July 23, 2009

**Re: Storm Water Inspection at Ruscilli Residence / Franklin County
Permit #: 4GC02472*AG**

Re: Storm Water Inspection at New Residential Residence/Permit #4GC02482*AG

Figure 1: Install silt fence

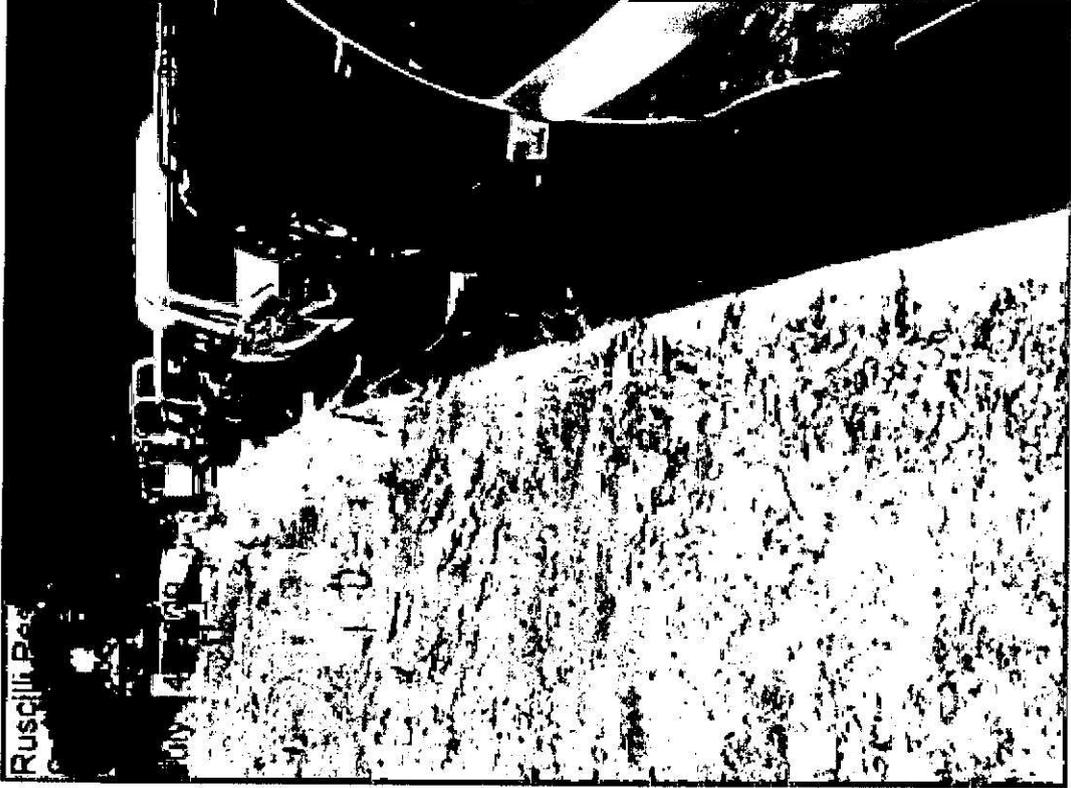
- Upon inspection, it appeared that all silt fence has been removed prior to stabilization. Please install silt fence along the street or provide a seed and mulch cover within 3 days from receipt of this letter (See Figure 1).
- In addition, please provide measures to centralize and contain the concrete wash out (See Figure 2).
